Canon SERVICE MANUAL REPORT

Service Manual No. L-005

Date 1971 / 7 / 29

Canon FD WIDE ANGLE Lenses Changes

1. FD 17mm 1:4 Design Change

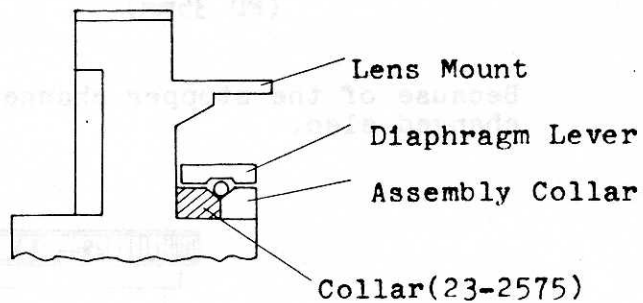
To improve quality, the cross-hatched part has been removed from the lens mount and made a separate part [Collar(23-2575)].

Camera Service will stock only the new lens mount and the collar. If an old mount is replaced with a new one, be sure to add the collar also.

2. FD 24mm 1:2.8 Lubrication

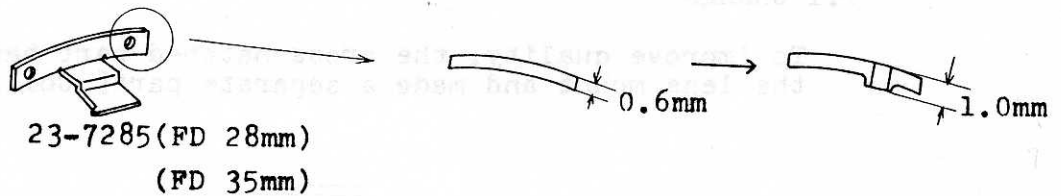
To insure the bell crank of the diaphragm always works smoothly the part of the lens barrel that it touches has been coated with baked-on dry lubricant paint.

No repair necessary.

3. FD 28mm 1:3.5 , FD 35mm 1:3.5 Bayonet Stopper

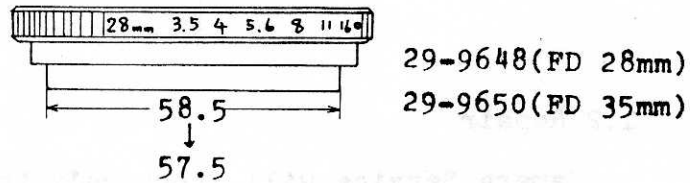
Bayonet Stopper(23-7285) had a tendency to crack around the screw holes, so the ends of the stopper around the screw holes have been thickened as shown in the drawing.

Because of the stopper change, the aperture scale ring has been changed also.

Old and new parts are interchangeable, but if the new stopper is used, the new aperture ring must be used also. Camera Service will stock only new parts.
